**MONTGOMERY COUNTY PLANNING DEPARTMENT**  
**THE MARYLAND - NATIONAL CAPITAL PARK AND PLANNING COMMISSION**

**PROJECT:** 4824 Edgemoor Lane  
 SITE PLAN No. 820210040, SKETCH PLAN No. 320200020

**DATE:** February 8, 2021

**Image A: The Macaw 2 Mural (proposed public artwork)**

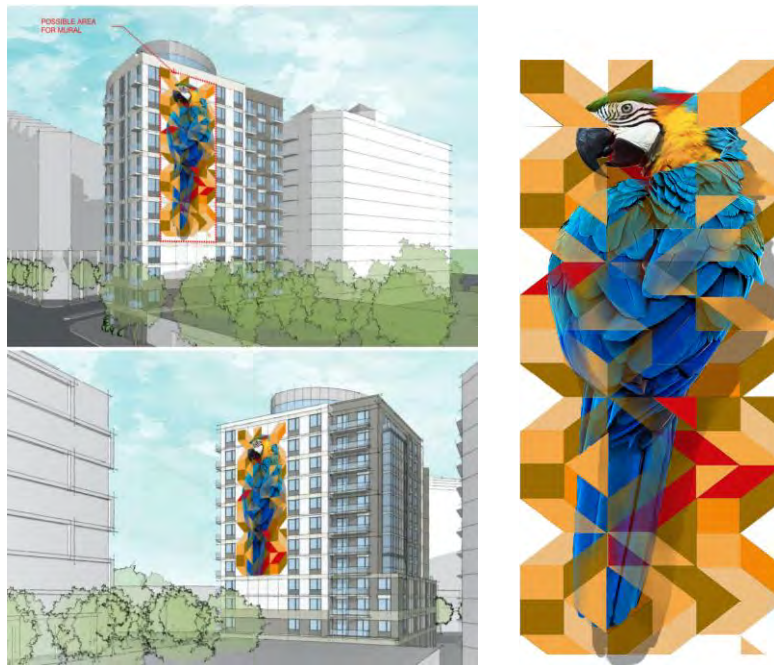
1. This Site Plan application was submitted in November 2020 and will be presented to the Planning Board in early April 2021.
2. The proposed mural on the western façade of the building is appropriate considering the alternative of having a simple blank wall. The geometric and abstract design concept of the Macaw 2 mural will be well-integrated into the building's architecture such that the mural could have a 3D effect that expands beyond the boundaries of the flat building façade and create the illusion of push and pull with the windows.

5. The Macaw (non-native tropical bird) provides a unique learning opportunity for viewers. The public art at this location resolves the issue of the blank surface on a new modern building within a community that has requested more murals. The Applicant is using the mural to work with the community and youth as a part of the construction process to make a noticeable statement to visitors.

1. The Art Review Panel supports the approval of 12 out of 20 public benefit points for providing a mural (public artwork) on the on the western façade of the proposed building.
2. The Art Review Panel supports the selection and approval of the original design of the Macaw 2 mural (Image A above). This mural is a creative solution for the blank space, will be integrated into the architecture, and creates more energy in the overall design of the proposed building. Please see Image A above.

**Images B, C & D – DRAFT Logo Sketches**

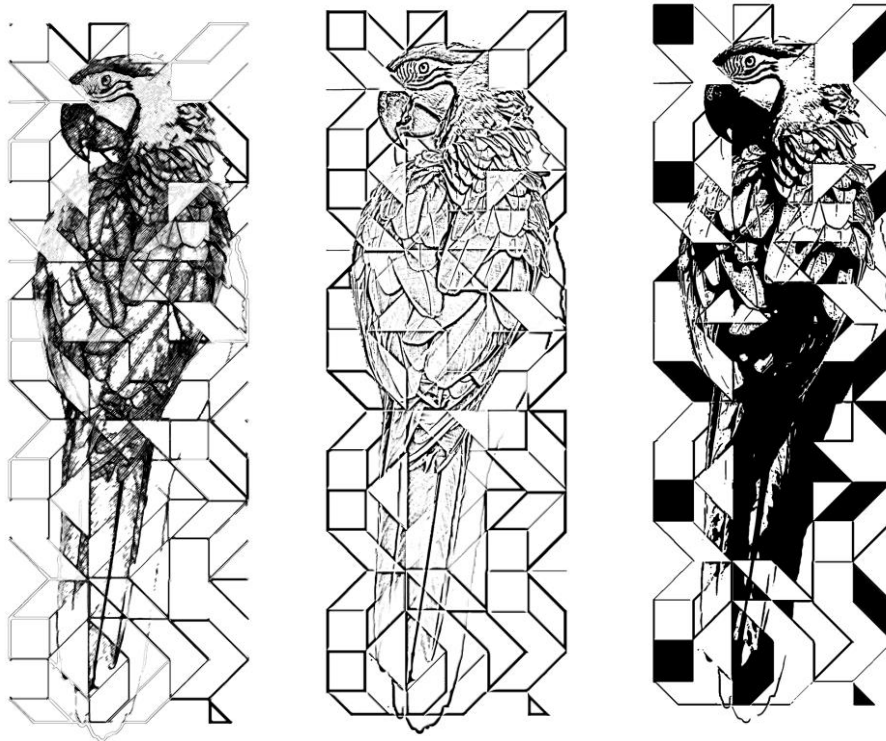
6. The Macaw 2 mural is expected to last approximately 10-years and comes with a maintenance and conservation agreement for 1-2 years. Restoration of this mural could increase the useful life to roughly 20-years.
7. The Macaw 2 image is recognizable and creates a strong identity that could be turned into a logo (**Images B, C & D below**). The draft logo sketches below were provided by Applicant and will be used to brand this development. The proposed mural has been reviewed by the BUP and is consistent with the CR Guidelines (criteria 3e above)

5. The Art Review Panel also supports the use of the Macaw 2 mural image as a logo for the new building.
6. The Certified Site Plan must contain site details that clearly indicate the overall dimensions, prescribed materials, necessary lighting fixtures, footers, and fasteners to ensure adequate safety and proper inspection of the artworks by the AHCMC and Montgomery County Department of Permitting Services (DPS). This information will be derived from engineered drawings, certified by a structural engineer.
